# AF1 KIT CHANGES AND MANUAL ERRATA

Rev. A-4, January 23, 2008

J1 - AF IN

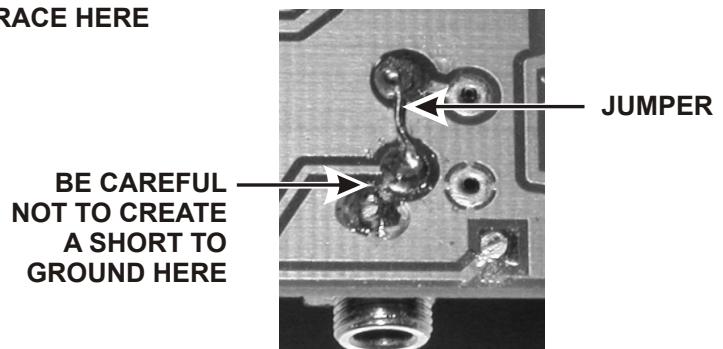
If the circuit board in your kit is Revision A (shown in the lower left corner on the top of the board), make the following changes so it will work properly with a monaural plug at the input and a stereo plug at the output. (This will be corrected in future revisions of the board.)

- At the pins of J1 (AF IN) on the bottom of the board, use a sharp knife to cut and remove the segment of the trace shown below. Use the green insulated wire to make a jumper to reach between the pin on J1 shown and the small hole at the circuit via where the trace passes through to the top of the board. This change isolates the ring connection so a monaural plug at J1 it won't short the audio to ground.
- At the pins of J3 (AF OUT) on the bottom of the board, install a jumper between the pins shown below. Use a short section of the green insulated wire or a discarded component lead. Take care to ensure the middle connection of J3 is not shorted to ground. This ties tip and ring together so audio is present on both at the output.
